SUBMITTAL NO.: 8

PROJECT TITLE: STFPD No. 1 Fire Station #18

SPECIFICATION SECTION NO.: 13125

**Review of Sheets E1 thru E17**

SIDEWALL ELEVATION "SWC" AT GRID LINE "C.9"

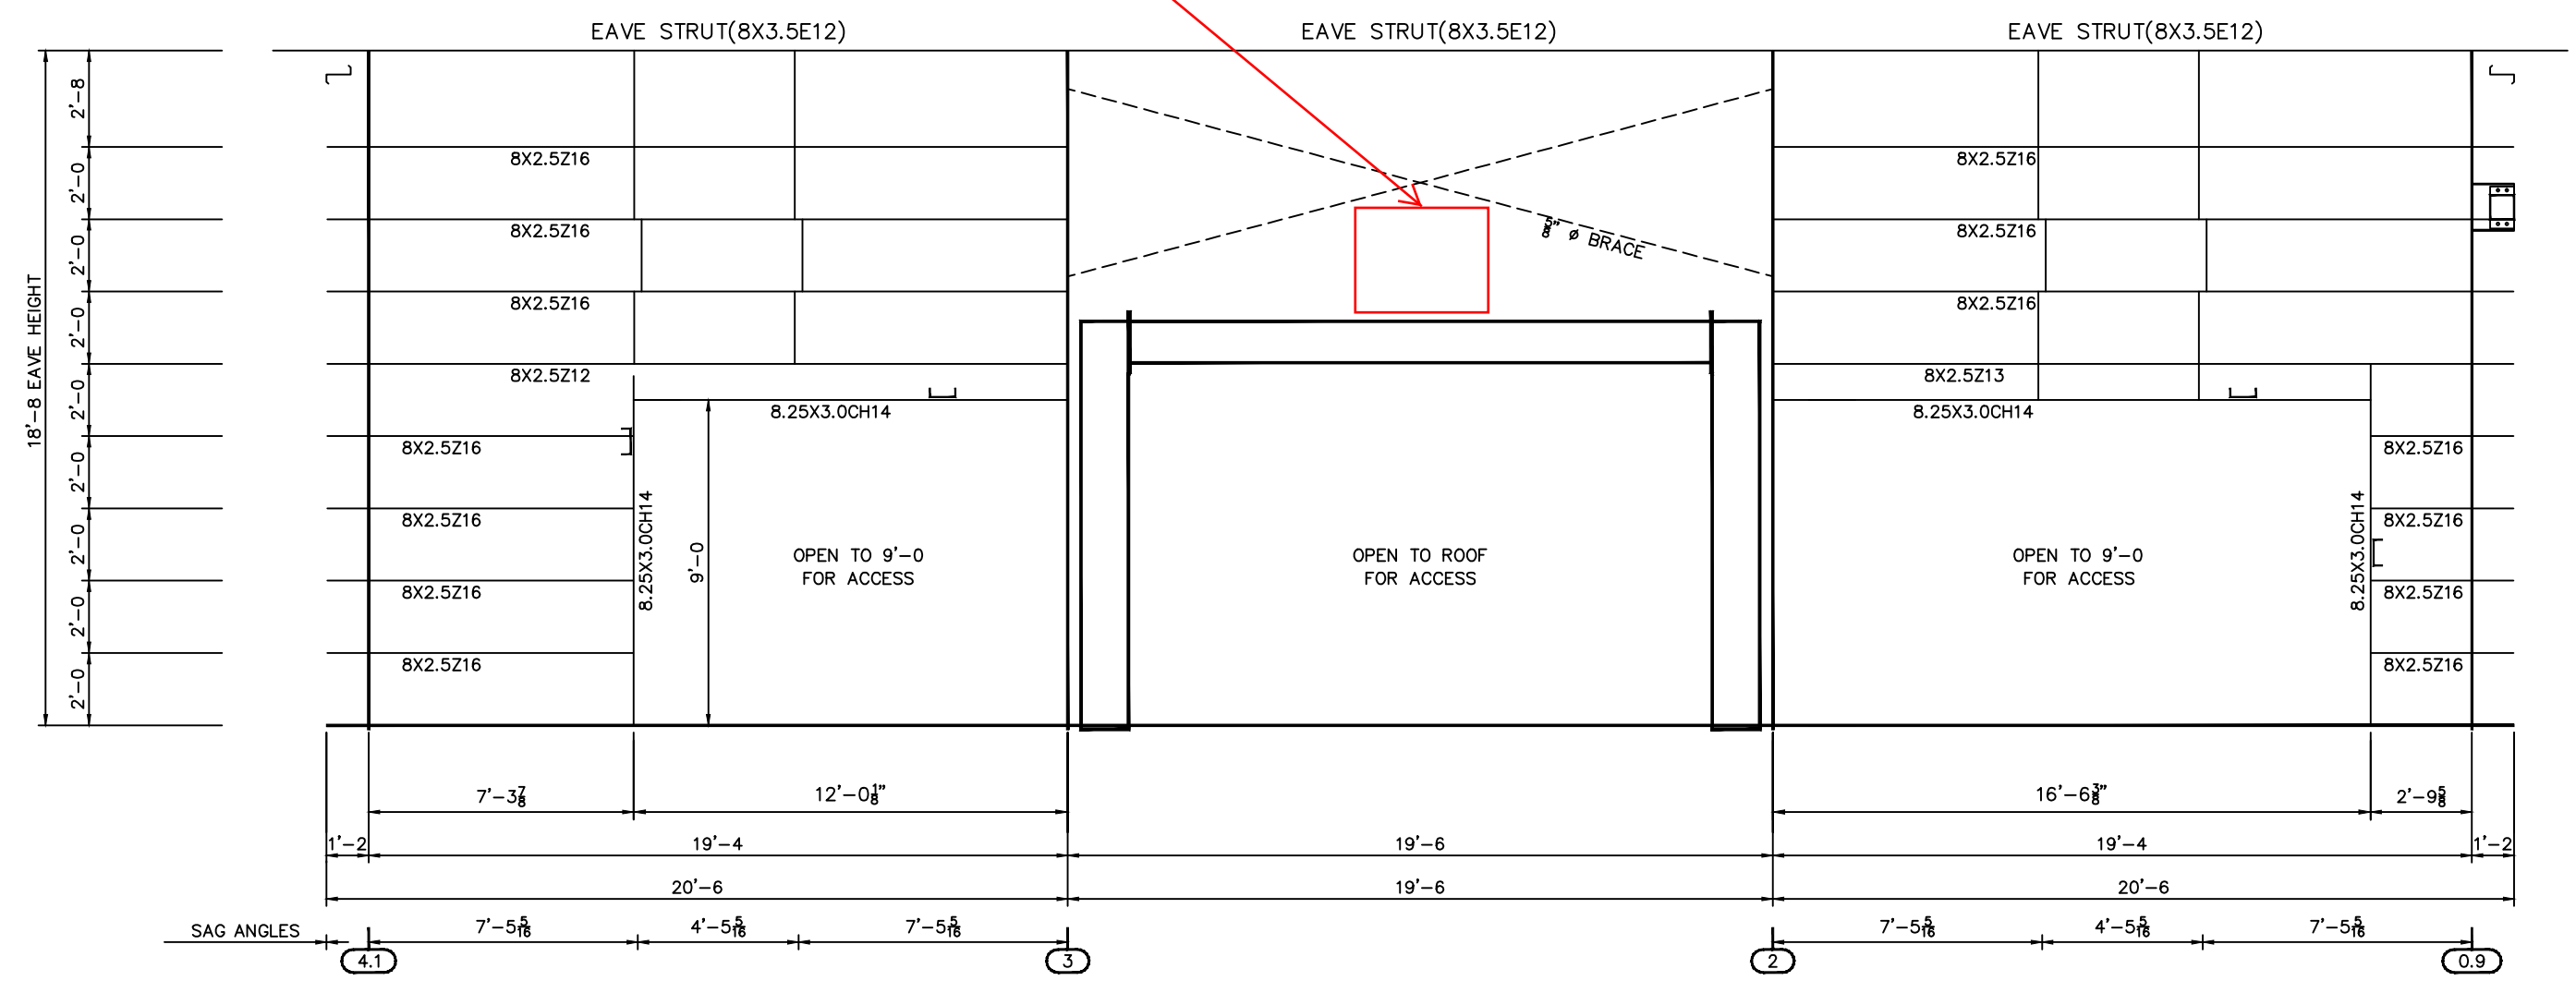
36" x 36" Fire Rated Maintenance Access Panel
